PLANNING COMMISSION MEETING

A G E N D A
May 23, 2023
7:30 PM

b. Motion to approve the Preliminary/Final Land Development - LD-22-06 - 2620 West Moreland Road (Raising Cane's).

SHEET NUMBER:
C5.0
10 OF 28

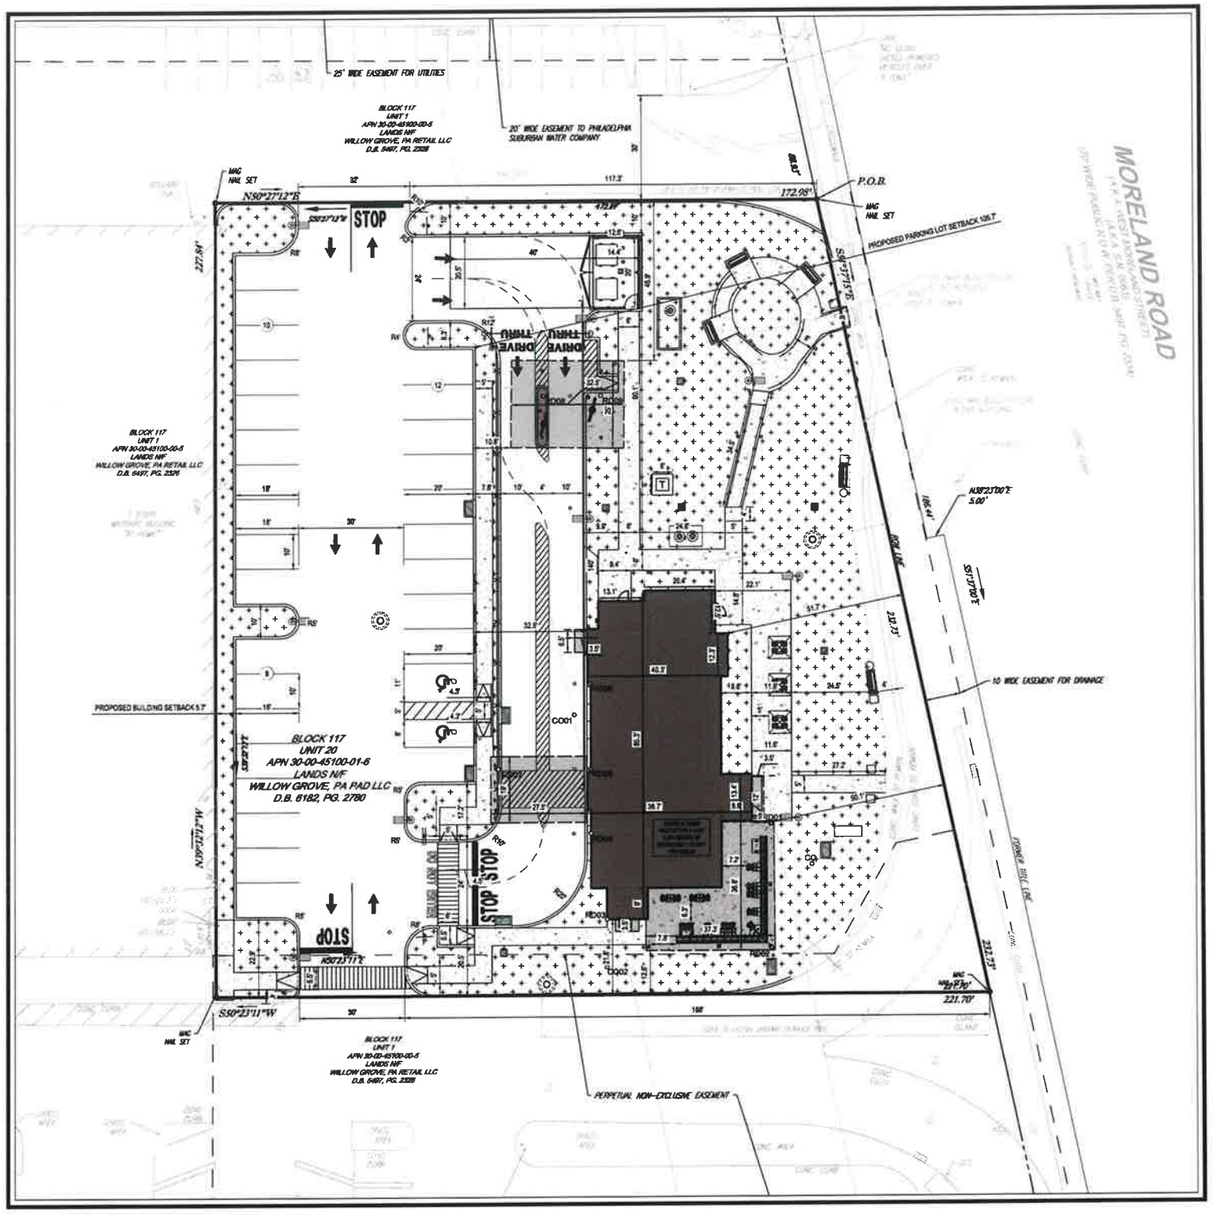
39. Per §146-11.B.(8).(b) & §146-11.D.(4) – Existing Features Plan & Grading Plan – The existing features plan shall contain the datum to which contour lines refer. This note shall be provided on the Existing Conditions plan (Sheet C4.0) and grading plan (Sheet C6.0) per Section 146-11.D.(4).

Response: Note stating "Existing Contour Information are based on the NAVD88 Datum" has been added to Sheets C4.0 and C6.0.

SHEET NUMBER:
C7.0
17 OF 26

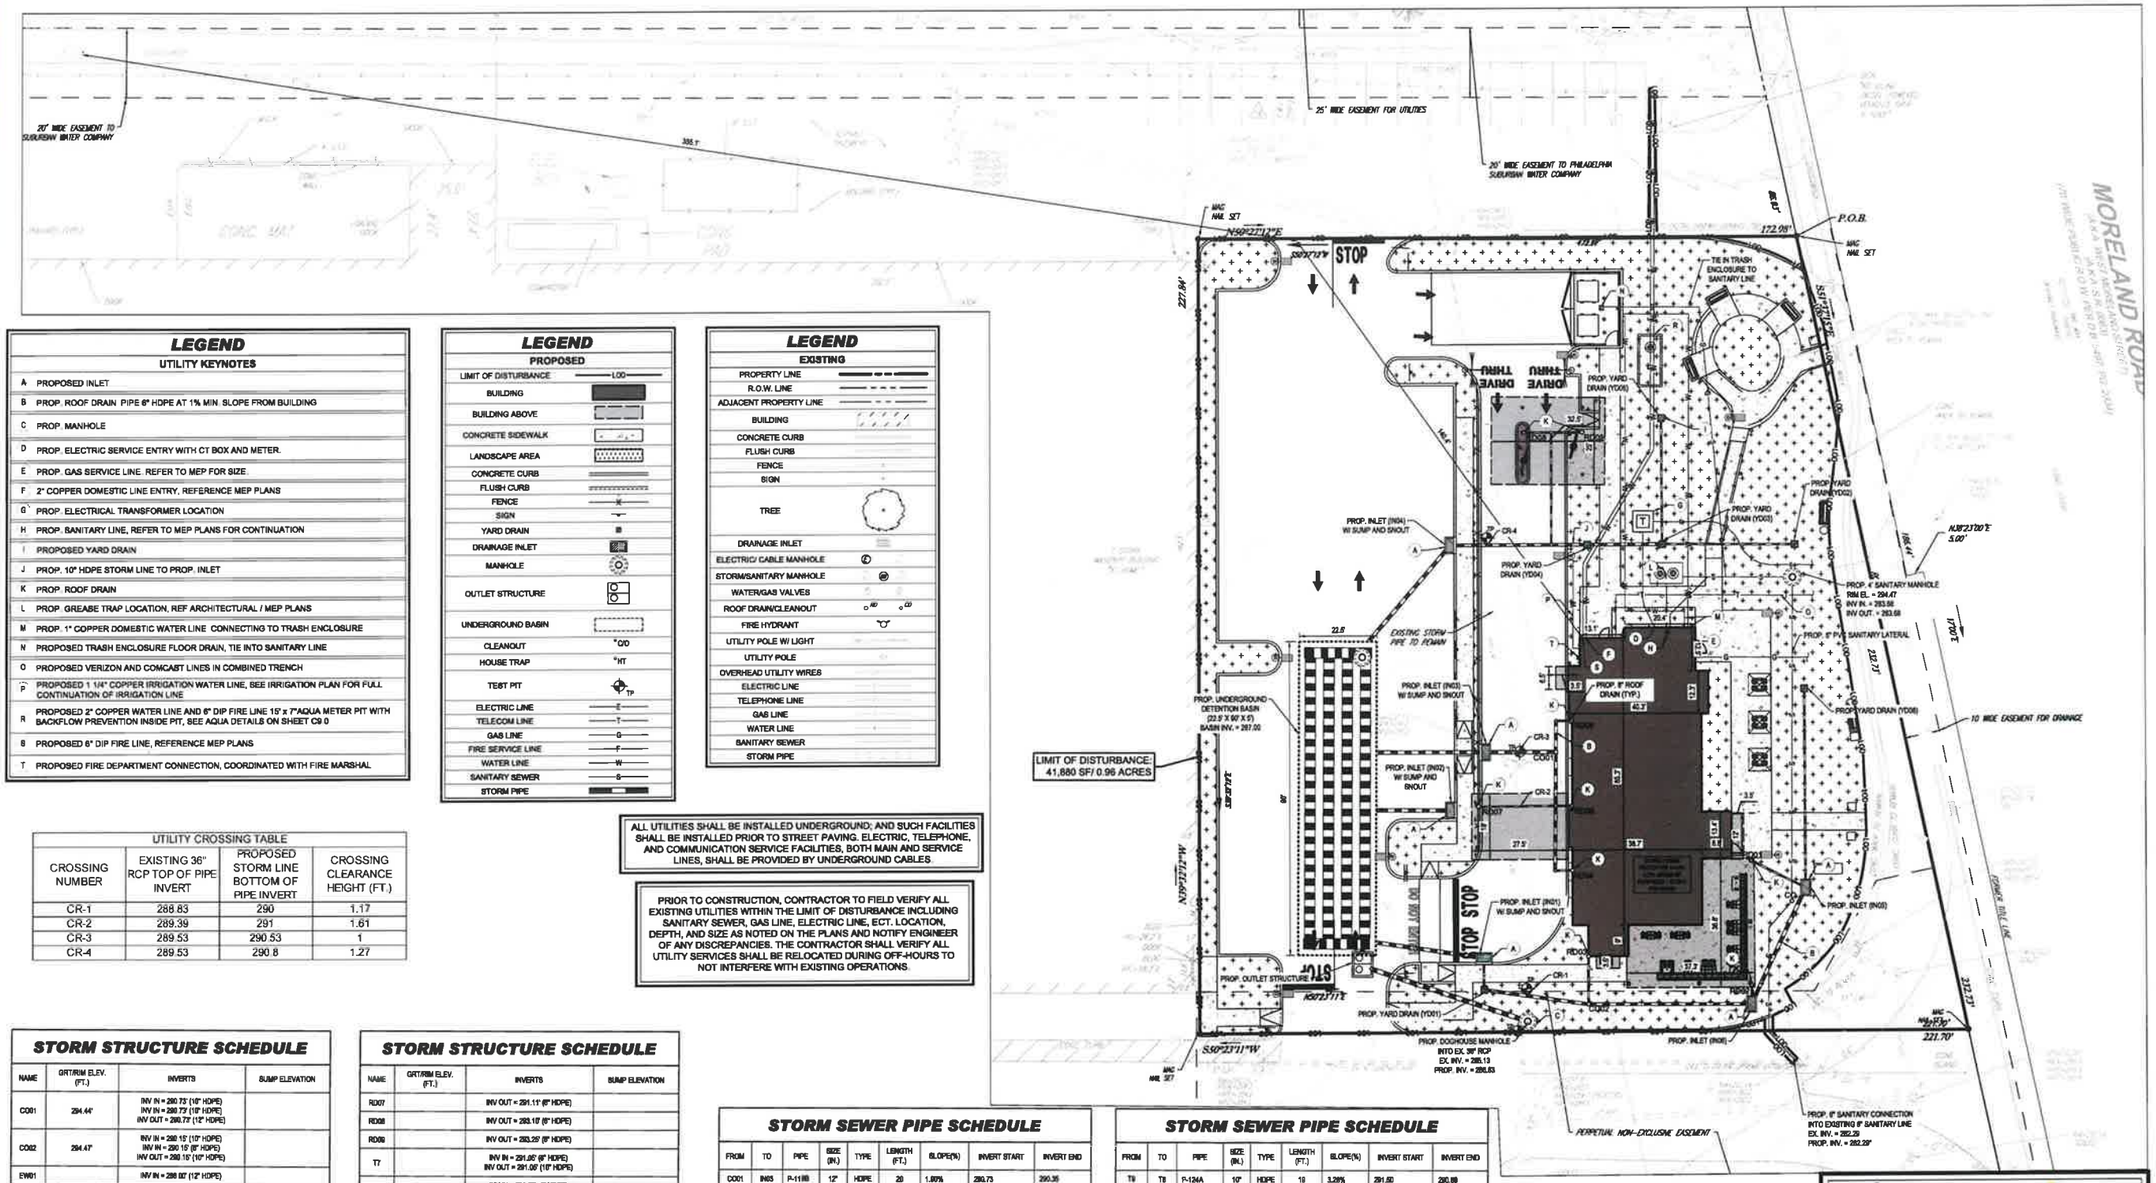
5. Would the applicant clarify drainage for the trash enclosure area for the restaurant? On sheet C7, Utility Plan, the legend indicates that the trash enclosure floor drain ties into the storm sewer system, but the plan indicates tie-in to Sanitary Sewer. We recommend that this be tied to Sanitary Sewer line to capture any pollutants that might run off from trash enclosure areas, especially since this area is not covered.

Response: This was a typo, the Trash enclosure floor drain is to tie into the sanitary sewer. Please see Sheet C7-0.

SHEET NUMBER:
C11.0
24 OF 26

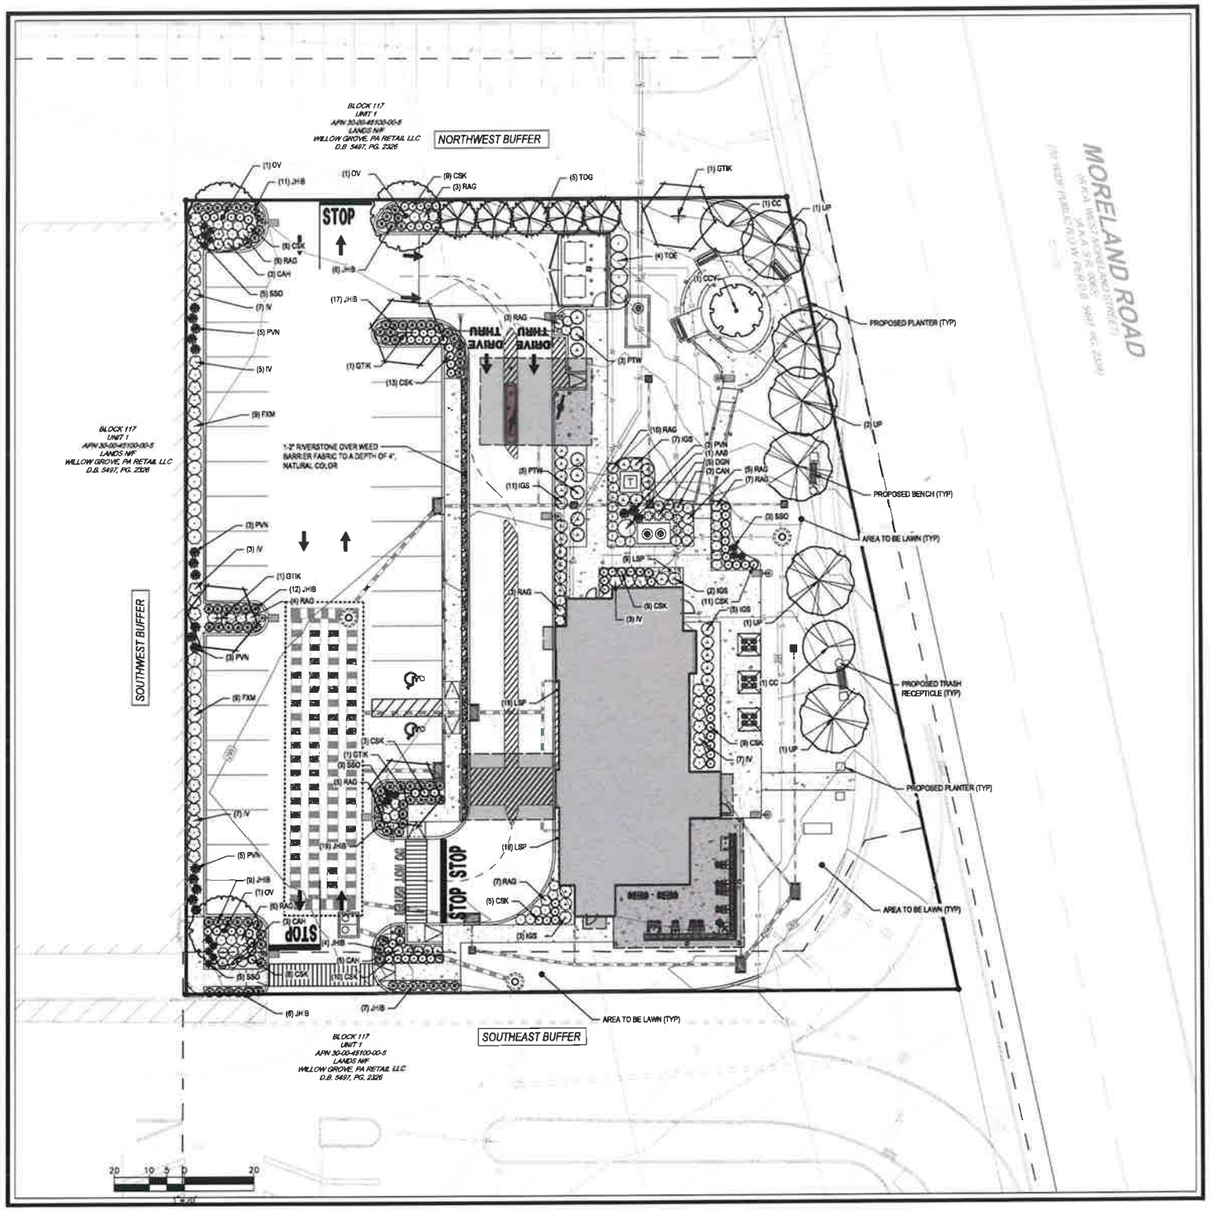
9. With respect to the landscaping specifications (Sheet 20), Notes G and H appear out of date and do not reflect current practice. Specifically, with respect to Note G: Trees can be planted year-round; in the fall, they need to be planted after dormancy, so they should be dug late in the fall. With respect to Note H: Trees should be backfilled with native material. If the native material is unsuitable, the backfill should consist of a mixture of 80% topsoil and 20% compost.

Response: Notes G and H have been revised slightly (sheet C11.0).

2 A4.10 **FRONT ENTRY ELEVATION**
SCALE: 1/4" = 1'-0"

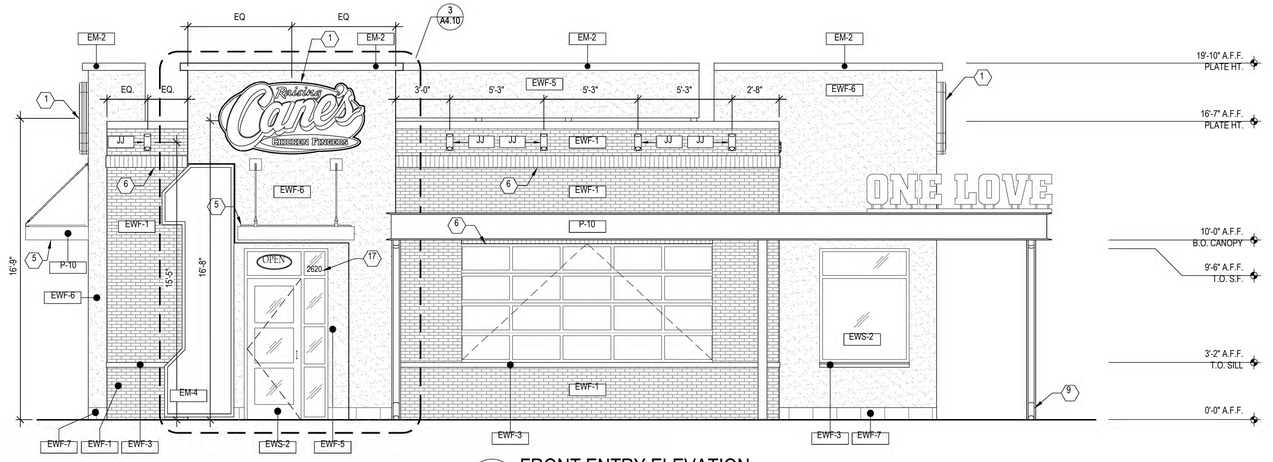
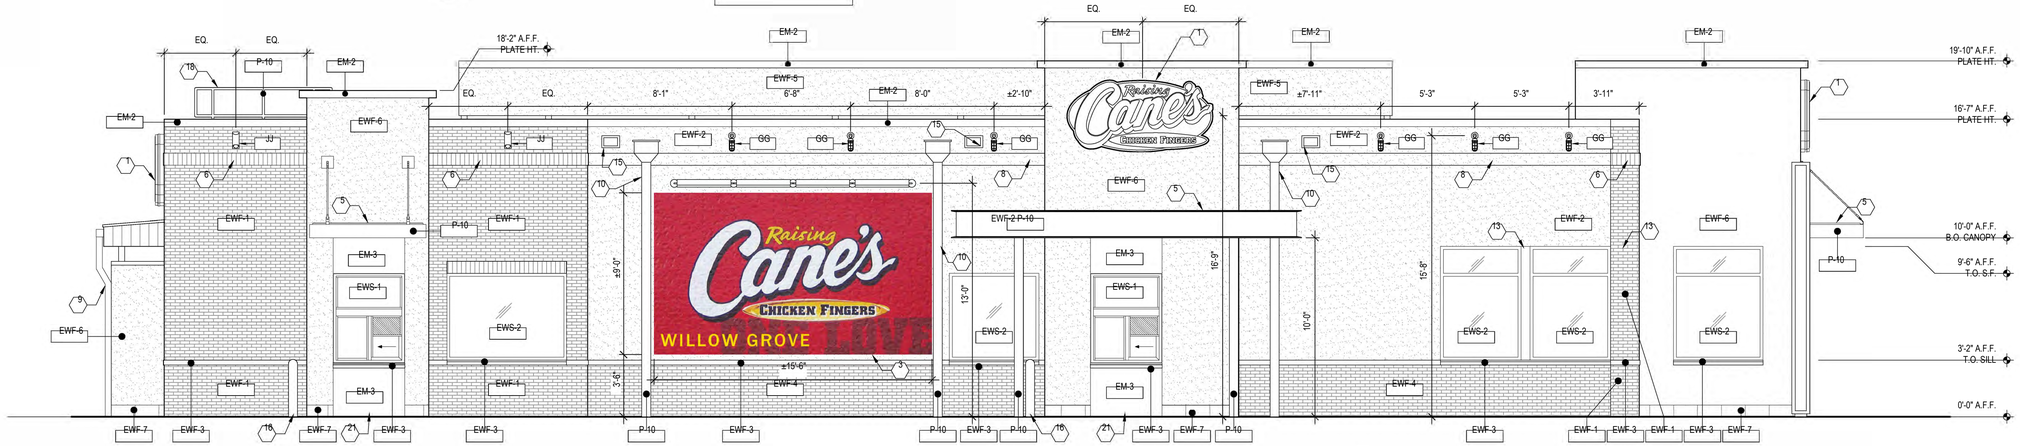
The Applicant shall confirm that the HVAC and mechanical equipment is screened from public view as indicated in this Code Section.
The Applicant has confirmed that the rooftop HVAC and mechanical equipment is screened from public view as provided on sheet A4.10. The Applicant shall submit revised architectural plans for review.

Response: Confirmed. The rooftop HVAC and mechanical equipment is screened from public view as shown on sheet A4.10
